# VENETIAN URBAN DESIGN WAIVER STAFF REPORT FOUR POINTS BY SHERATON

October 15, 2019  
18-01WV

**PETITION NOS.:** 18-01WV

**REQUEST:** Waiver of requirements of the Venetian Urban Design (VUD) overlay district regarding parking, required yards, and architectural design for the development of a 4-story, 103 room hotel and a 30 seat restaurant.

#### **Waiver Request No's. 1-3**

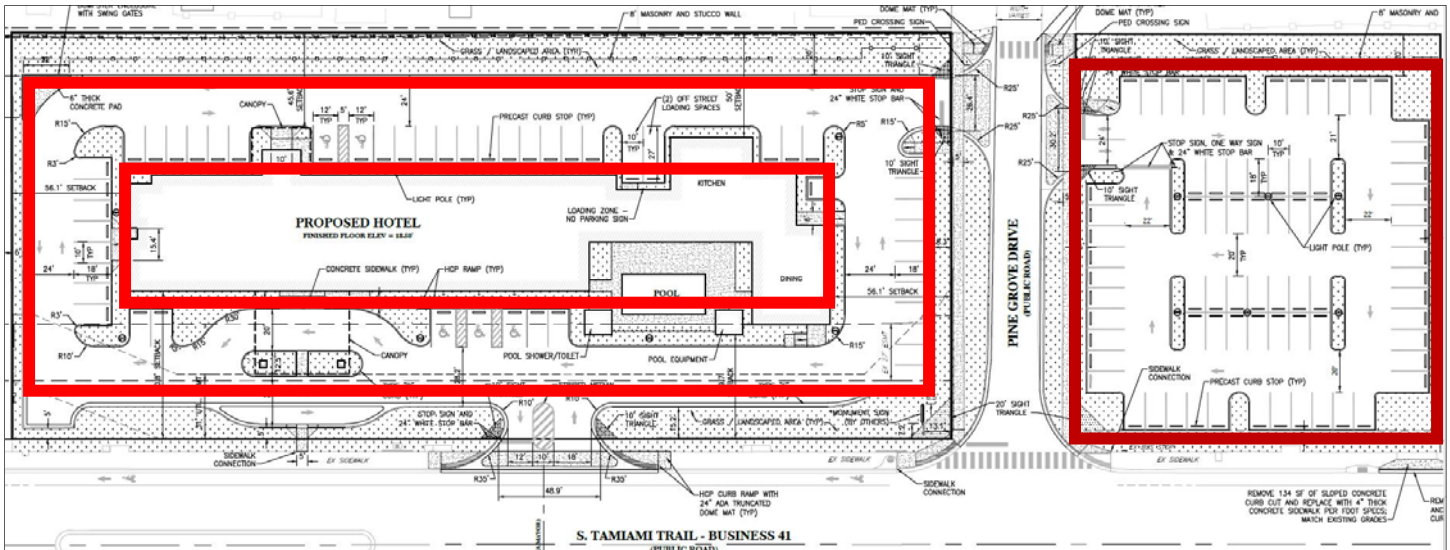
1. Waiver from Section 86-122(l)(4)(b) that indicates on-site parking shall not be visible at the street level.  
The applicant's design of the project provides street level parking on both the main hotel parcel and the

separate parking lot parcel. Obviously the parking lot parcel is completely made up of parking for guests and employees of the hotel. The site provides screening and buffering along all property lines consistent with the requirements of the VUD overlay district with emphasis on the rear of the site adjacent to the existing single-family homes on Guild Drive. Although the landscape buffering proposed by the applicant does screen the parking, it will still be visible from some vantage points.

Regarding the main parcel proposed for the hotel building, the applicant's design includes surface parking on all four sides of the structure, including minimal parking along Tamiami Trail. Similar to the offsite parking, landscape buffering has been included to screen the parking as much as possible. However, it will still be visible from certain locations.

Project seeks waiver from Section 86-122(l)(4)(b) which states that on-site parking shall not be visible at the street level, in order to allow on-site parking that is partially visible at the street level.

- d. *Intent of implementation; hotel site. The 4 parking spaces and 3 handicap spaces in front of the building will be screened with landscape trees, bushes, plantings, and grasses, as well as a 5' high line of shrubs, per applicable buffers. This will in effect "hide" the parking from street view.*

- e. *Intent of implementation; parking lot site. The stand-alone parking will be heavily screened with landscape trees, bushes, plantings, and grasses, as well as a 5' high line of shrubs, per applicable buffers. This will in effect "hide" the parking from street view.*

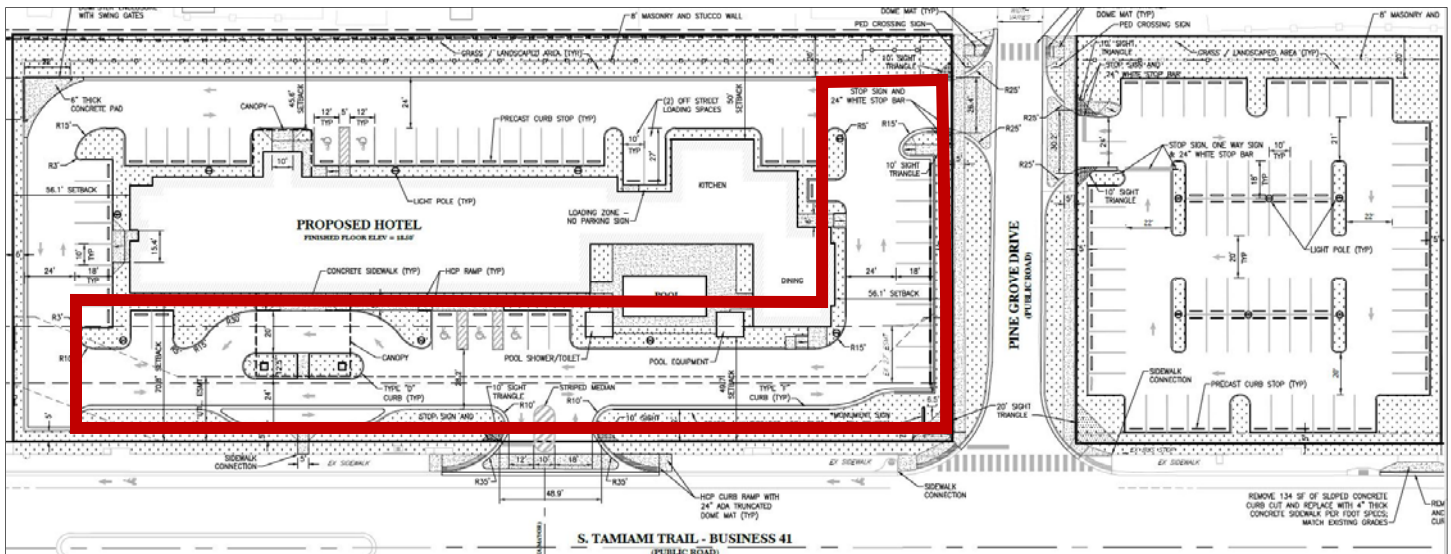
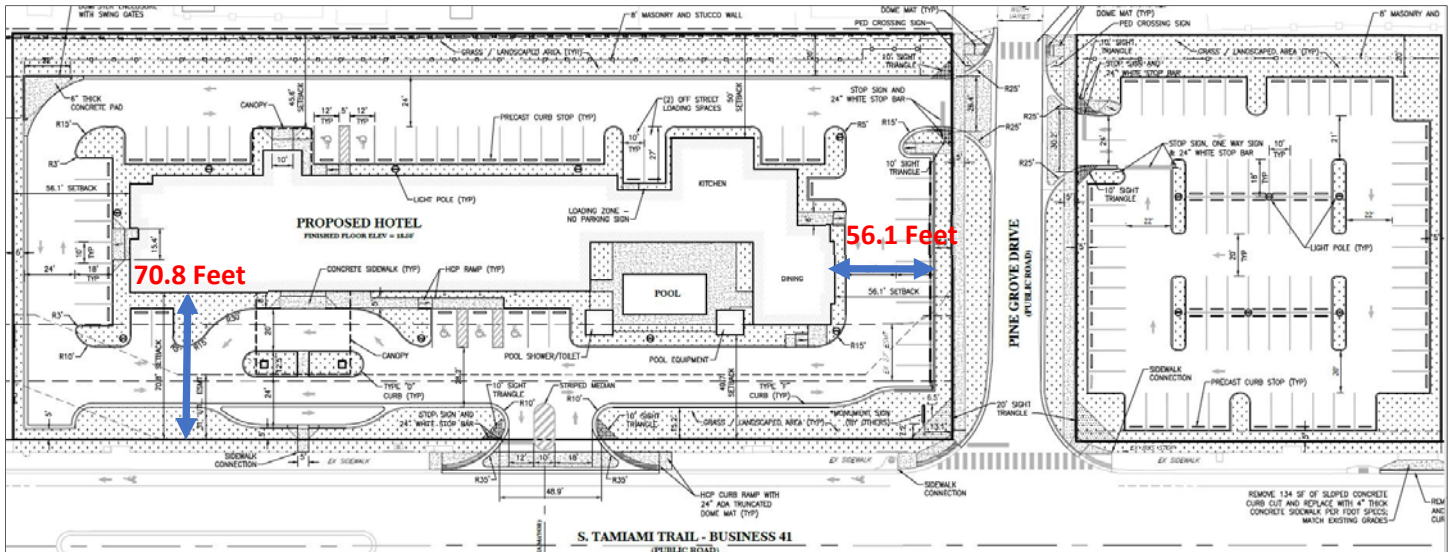
2. Waiver from Section 86-122(o)(1) that indicates parking is prohibited in front of buildings and structures. As indicated above, the applicant's design includes parking in front of the proposed hotel building. The subject code section states "In order to help promote walkability and community interaction within this mixed-use commercial district, the VUD seeks to mitigate the visual and spatial impact of vehicular parking. As such, the purpose of these standards is to encourage the placement of parking behind buildings and structures."

*Project seeks waiver from 86-122(O)(I) which prohibits parking in front of buildings and structures, in order to allow parking in front of the hotel development.*

- d. *Hardships. Moving handicap parking spaces away from the main entrance would be against ADA requirements. Parking counts need to be met.*
- e. *Intent of implementation. Owner has redesigned site to eliminate almost all parking from in front of building. Handicap parking spaces are required at building entrance by Code, and a few left over spaces (4) remain for parking counts. All parking spaces in the front of the building do not abut the street directly but are aligned across the drive up against the building sidewalk.*

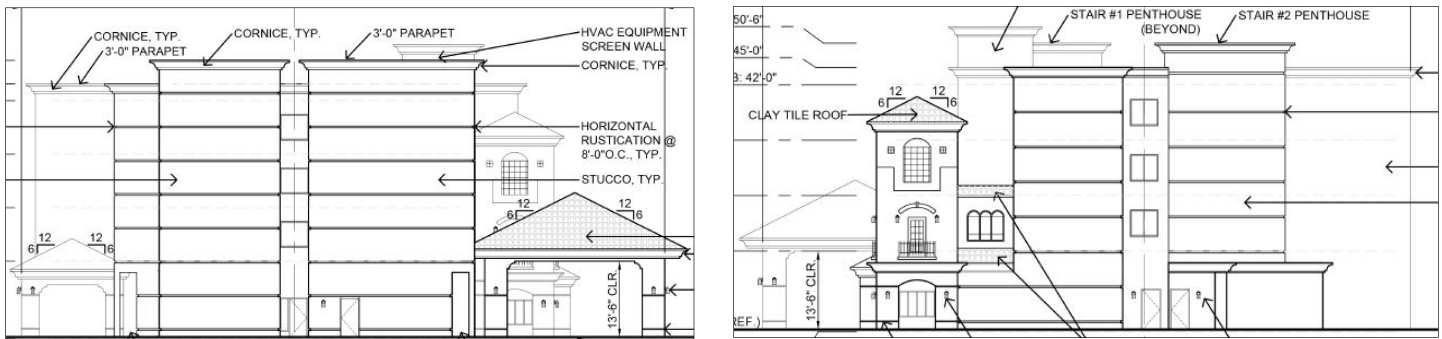
3. Waiver from Section 86-122(l)(4)(a) that provides for a front setback of no greater than 15 feet. This code section indicates that "New buildings shall be sited on the property within the front portion of the property, with a setback no greater than 15 feet from the property line in order to facilitate pedestrian activity by providing a compact, continuous stretch of mixed uses." The applicants design for the project provides for a 70.8 foot setback from the property line along Tamiami Trail to the hotel building which is

the main focus of this code standard. As Pine Grove Drive would also be considered a front yard, the applicant also exceeds the maximum 15 foot setback in this area with the provision of a 56.1 setback.

*Project seeks waiver from 86-122(l)(4)(a) which states that new buildings shall be sited on the property within the front portion of the property, with a setback no greater than 15' from the property line, to allow building to be setback from road more than 15'.*

- e. Intent of implementation. Building has been moved as close to the road as possible while still maintaining an access point at the front door and allowing handicap parking/access to the building.*
